Intel® High Definition Audio Specification

Document Change Notification

Change Identification: **DCN No: HDA043-A**
Change Revision: 1.0
Document Revision: Intel® High Definition Audio 1.0a

Title: **Energy efficient audio buffering and dynamic FIFO limit change**

Figure 14: HD Audio DMA and buffering

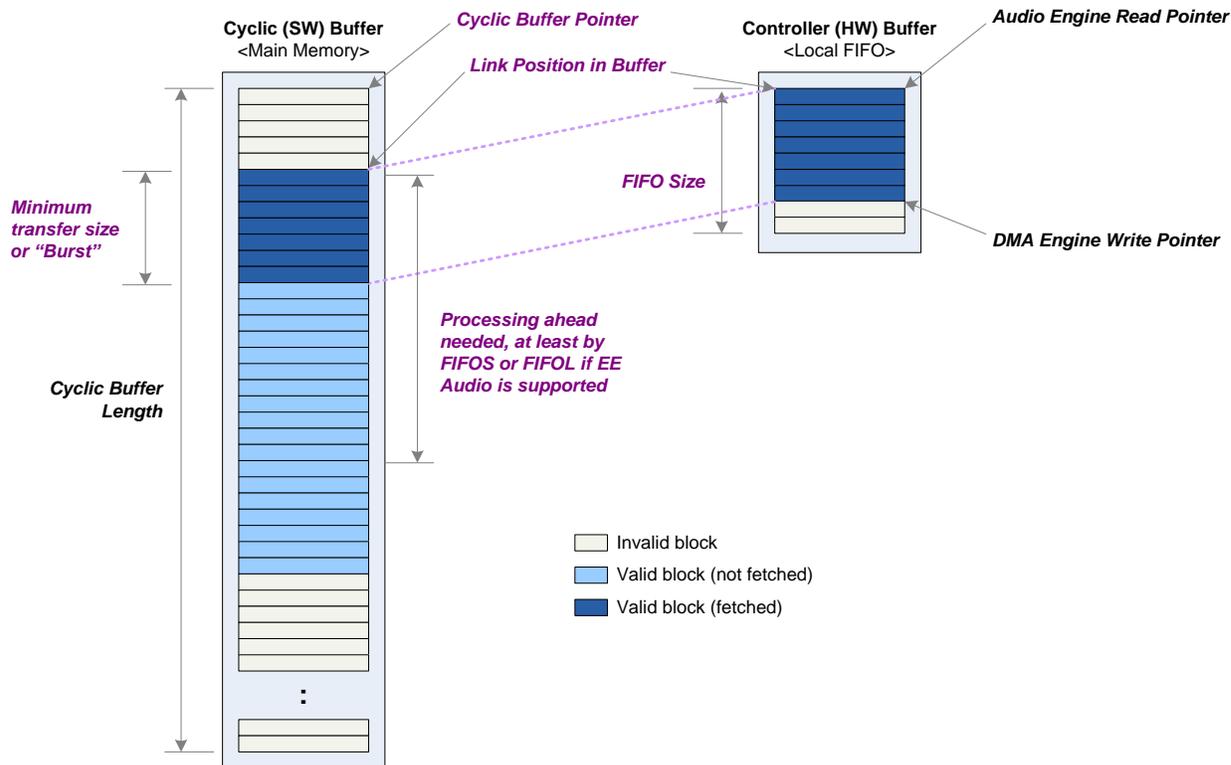
The GCAP2 register EEAC bit indicates the HW capabilities of supporting EEAudio. When EEAC bit is set, the FIFOL register is available for SW to specify the limit (in unit of time) that HD Audio Controller DMA engine can access in the Cyclic Buffer, ahead of the Link Position in Buffer; in other words, that defines the maximum limit that DMA engine effective buffer size (in number of bytes) can be extended to. SW shall guarantee processing ahead of this boundary in the Cyclic Buffer. Note that the translation of FIFOL value to effective buffer size needs to take into consideration of number of channels, sample size, multiplier, divider, and base rate.

When EEAudIo is supported as indicated by EEAC bit being set, the FIFOS register will expose the minimum buffer size required by HW for efficient operation. SW can allow the extension of the DMA engine effective buffer size beyond the minimum buffer size advertised in FIFOS register for better power management, by writing to FIFOL register followed by setting FIFOSC bit. Depending on the eligible HW buffer size available, DMA engine can then extend its effective buffer size to a value not exceeding the FIFOL specified. Note that some HD Audio Controller DMA engine implementations are capable of changing FIFOS register value based on FMT register programmed, hence, SW shall always read the FIFOS register to find out the FIFO size advertised before writing to FIFOL register.
